# Delegated Report

## Householder Planning Application

**Planning Application No:** 20221108

**Description:** Creation of a parking area surfaced with porous tarmac and finished with resin bound gravel.

The below images show (i) the access and hardstanding as approved on appeal, (ii) what has been carried out on site and as proposed in previously refused application ref. 20220586 and (iii) what is proposed in this current application:

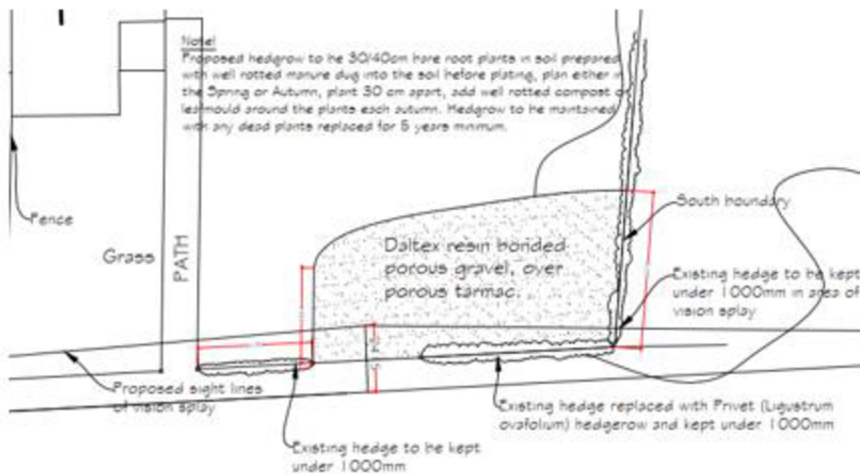
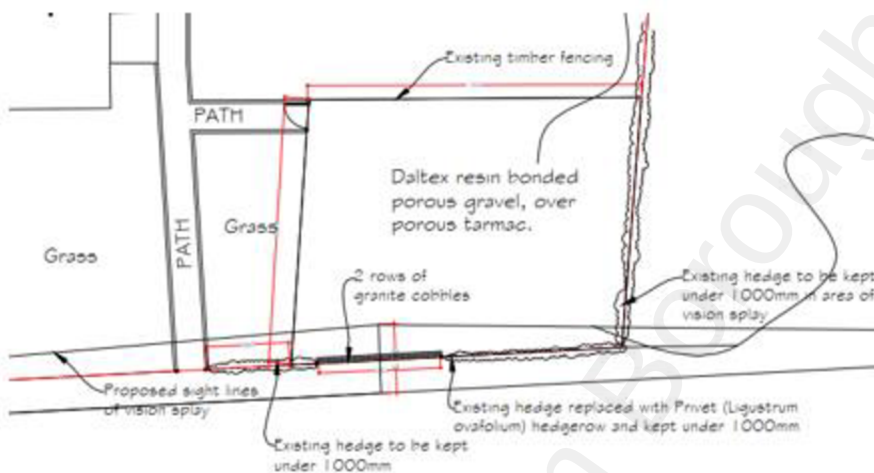
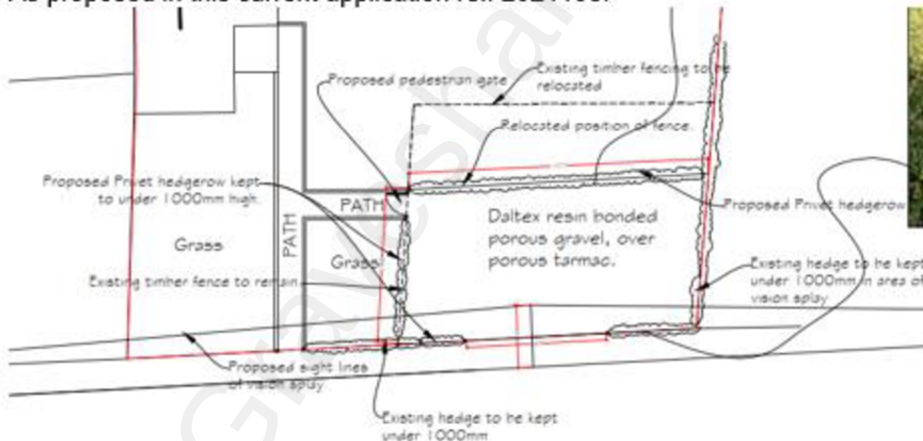
The differences are:

The access to Thong Lane to be slightly wider (increased from 4250mm in width to 5400mm in width – an increase of 1150mm) and moved slightly to the south of the approved position in order that the drive is accessible for vehicles reversing in according to the Design and Access Statement. Hedgerow would be reinstated in the gap created from moving the access southwards;

Reduction in depth of the hardstanding area as carried out on site (9298mm to 5998mm depth). It would be

brought back to the same depth as the deepest part of the hardstanding approved on appeal but with the squaring off of the north-eastern corner as opposed to the curved corner as approved on appeal;

The fencing along the eastern boundary of the hardstanding would be brought forward to reflect the new reduced depth of the hardstanding and hedging proposed along this fencing and the fencing along the northern side of the hardstanding.

The existing unauthorised enlarged area of hardstanding would be reduced in size back to the depth as approved on appeal, albeit it would have a squared off north-eastern corner but overall the proposed area of hardstanding which would only be slightly larger than that granted on appeal would not be excessive. The fencing along the northern and eastern boundaries of the hardstanding and which is currently considered an incongruous addition would also be altered. No fencing was proposed in the application granted on appeal. The fencing that has been erected along the eastern boundary of the hardstanding would be brought forward in line with the proposed reduced depth hardstanding and would be covered with a proposed privet hedge with the previous area of hardstanding laid to grass. The fencing along the northern boundary of the hardstanding would remain in its current position but would also be covered with a privet hedge. This re-location and concealment of the fencing with hedgerow is considered an improvement and would mean the fencing would no longer appear as an incongruous feature. The approved access would be widened and moved slightly further south but the 1.1m increase in width is not considered overly excessive over what has already been granted on appeal, to warrant refusal and a privet hedge is proposed in the gap which would be created by moving the access further south. The materials appear to be the same as approved - Daltex resin bonded porous gravel over porous tarmac but limited information has been submitted. It is considered that notwithstanding the details shown on the submitted plans and documents, should permission be forthcoming conditions would be required concerning landscaping to ensure the exact landscaping to be installed and also surfacing to ensure exactly what area is to be surfaced and with what and to ensure that the element which is to be returned to grass is and that the development is carried out in a sufficient time given the current unauthorised works.

Overall it is considered that the proposed changes to the scheme granted on appeal are acceptable in respect of design and heritage matters. The open and verdant character of the site would still be retained and the character and appearance of the Thong Conservation Area would be preserved. It would rectify a current unacceptable situation in terms of the unauthorised works which have been carried out. In this regard the proposal would therefore be compliant with Policies CS19 and CS20 (LPCS) and saved Policy TC3 (LPFR) and as such the ground of refusal of previously refused application ref. 20220586 has been resolved.
